GENERAL ELECTRIC — 7E1E791TY — REACTOR RECIRCULATION SYSTEM

STONE & WEBSTER ENGINEERING CORPORATION
NINE MILE POINT NUCLEAR STATION - UNIT 2
NIAGARA MOHAWK POWER CORPORATION
J.O. 12177

MANUFACTURER'S DRAWING DATA FORM

MFR'S. DWG. NO. (C) (LIMIT TO 24 CHARACTERS & BLANKS) (37-80): 761E791TY, Sh. 18, Rev 2

SUCTION VALVE B35-F023A (2)
CKT 2RCS405
ESK-6RCS03

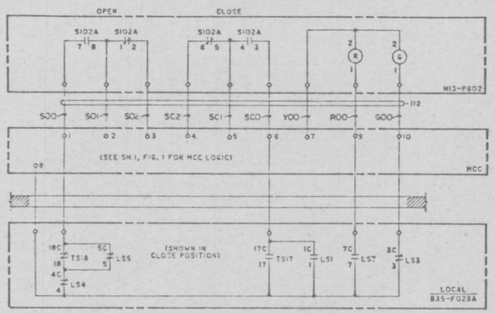
add ESK No.

① the marked changes also apply to control circuits for F023A, B & F067B shown on this dwg

(2) To agree with SEW's mov standards, make all the changes in control circuit as marked.

(3) As ITE mcc's are used on NMP2, revise terminal nos for mcc

SUCTION VALVE B35-F023B (2)
CKT 2RCS305
ESK-6RCS03

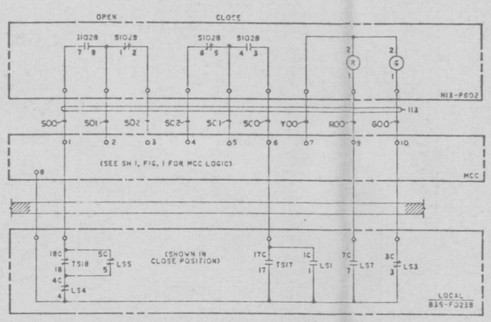
Shown "NC"

Shown "NO"

DISCHARGE BLOCK VALVE B35-F067A
CKT 2RCS403
ESK-6RCS01

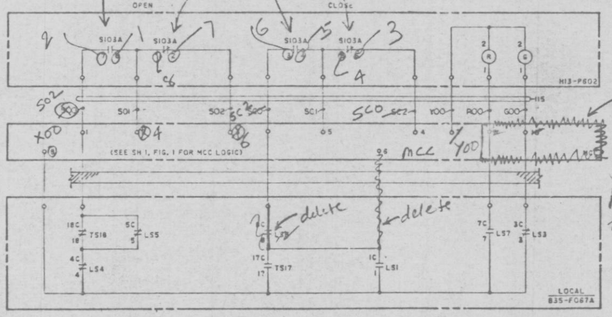
delete mcc is not to be used as junction point. Revise wiring to go from P602 to F067A directly
